SUNDRY NOTICES AND REPORTS ON WELLS
(DO NOT USE THIS FORM FOR PROPOSALS TO DRILL OR TO DEEPEN OR PLUG BACK TO A DIFFERENT RESERVOIR. USE "APPLICATION FOR PERMIT" (FORM C-101) FOR SUCH PROPOSALS.)

HILCORP ENERGY COMPANY
J R PHILLIPS B #006
P&A NOI

API #:	3002524799

Operator: HILCORP ENERGY COMPANY 1111 Travis Street Houston, TX 77002	OGRID: 372171
	Action Number: 545374
	Action Type: [C-103F] NOI Plug & Abandon (C-103F)

P&A WBD Proposed

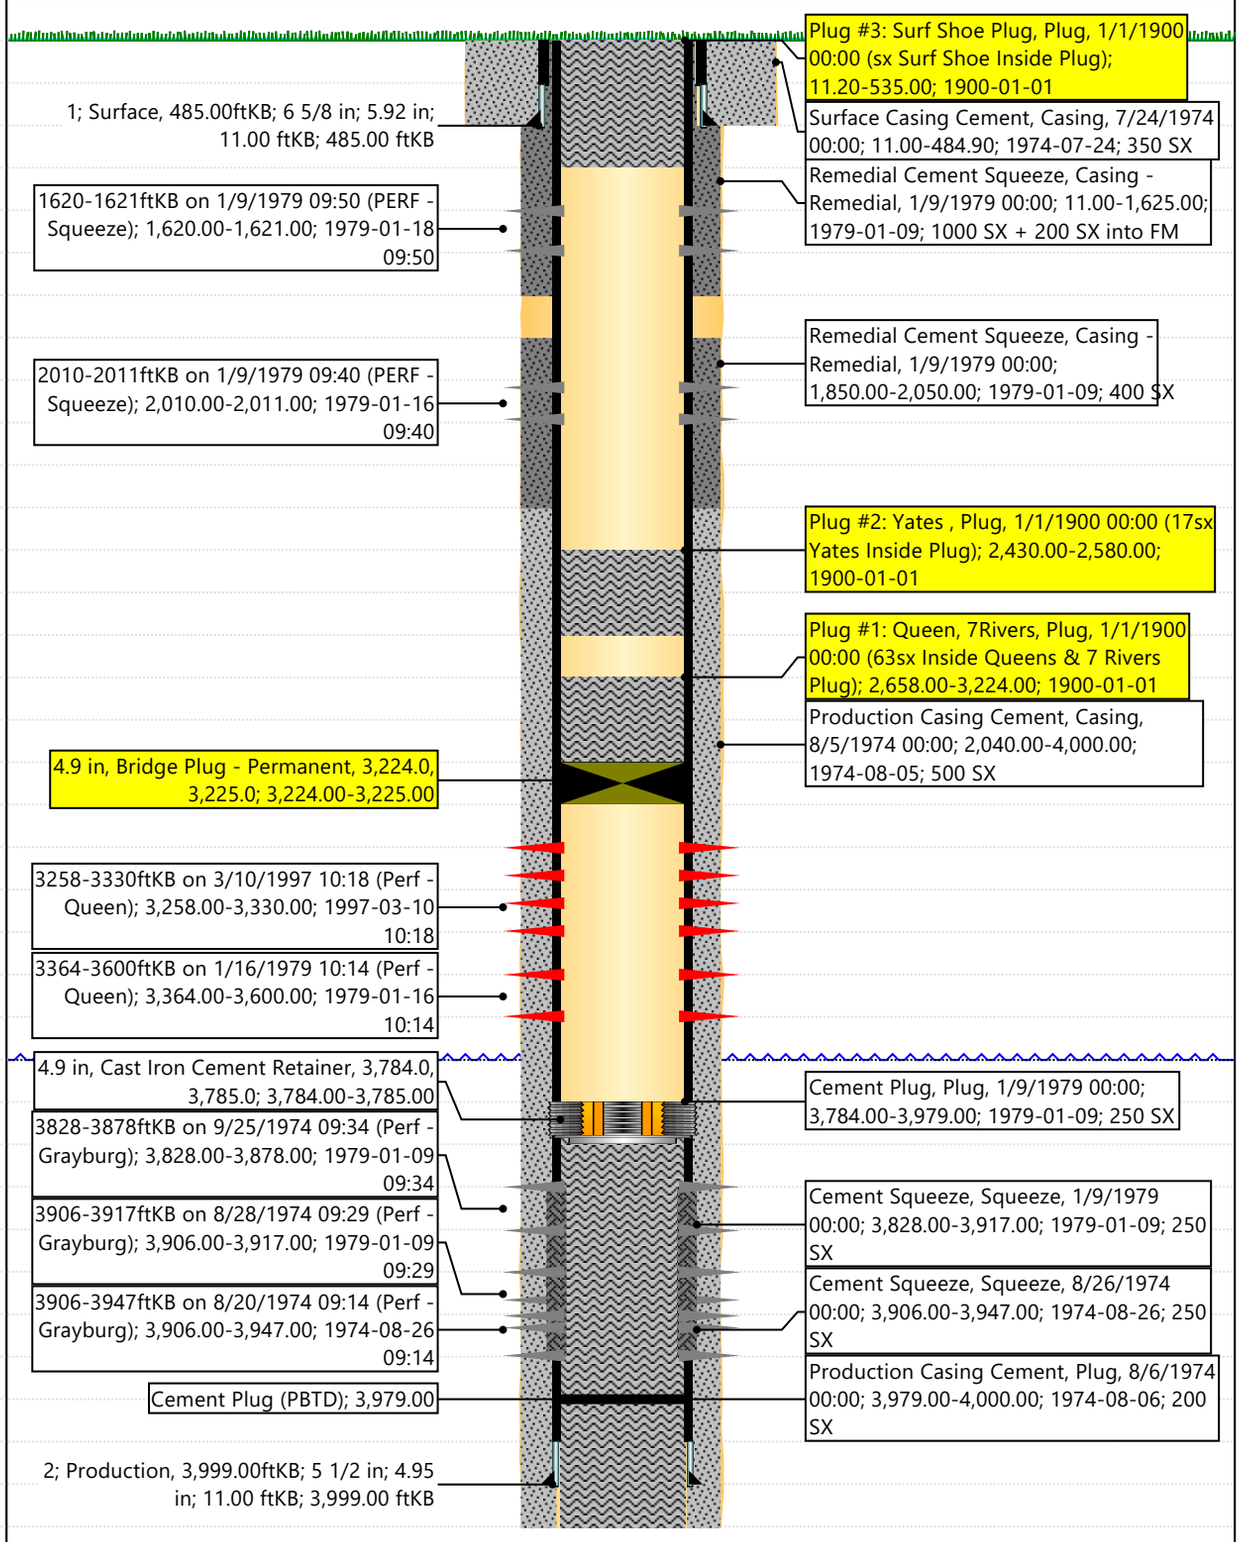
5. **PLUG #1: 63sx of Class C Cement (PPG, 1.22 yield); Q Perfs @ 3,274' | Q Top @ 3,274' | 7R Perfs @ 3,258' | 7R Top @ 2,758':**
   Pump an 63 sack ~~balanced~~ cement plug inside the 5-1/2" casing (est. TOC @ +/- 2,658' & est. BOC @ +/- 3,200'). WOC for 4 hrs, tag TOC w/ work string.
   *Note cement plug lengths and volumes account for excess.

7. Spot 22 sx cl C Cmt 1295' - 1180' - T Salt & Anhy.
8. **PLUG #3: 59sx of Class C Cement (PPG, 1.22 yield); Surf. Casing Shoe @ 485':**
   Pump an 59 sack balanced cement plug inside the 5-1/2" casing (est. TOC @ +/- 0' & est. BOC @ +/- 535'). *Note cement plug lengths and volumes account

APPROVED
GC 6/10/26
